Southern Nuclear
Operating Company, Inc.
Post Office Drawer 470
Ashford, Alabama 36312

FNP-023-NRC-DC

ATTACHED IS AMENDMENT NO. 147 TO THE TECHNICAL SPECIFICATIONS. PLEASE FILE IN
THE NEW IMPROVED TECH SPEC BOOK.

ATTACHMENT TO LICENSE AMENDMENT No. 147

Figure 3.4.16-1

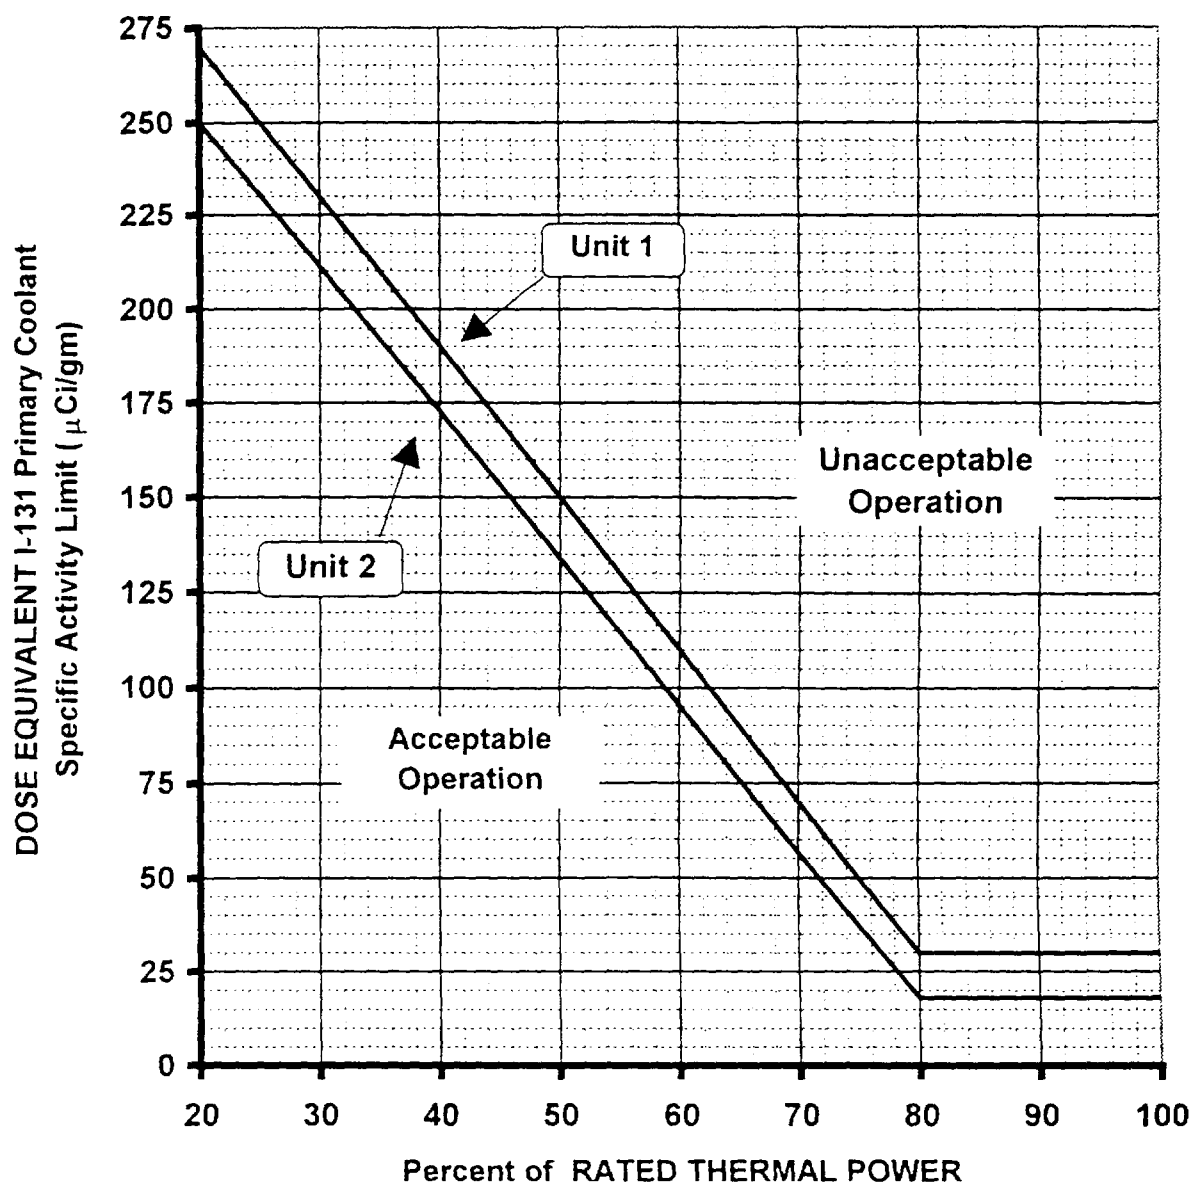
CONDITION	REQUIRED ACTION	COMPLETION TIME
<p>C. Required Action and associated Completion Time of Condition A not met.</p> <p><u>OR</u></p> <p>DOSE EQUIVALENT I-131 in the unacceptable region of Figure 3.4.16-1.</p>	<p>C.1 Be in MODE 3 with $T_{avg} < 500^{\circ}\text{F}$.</p>	<p>6 hours</p>
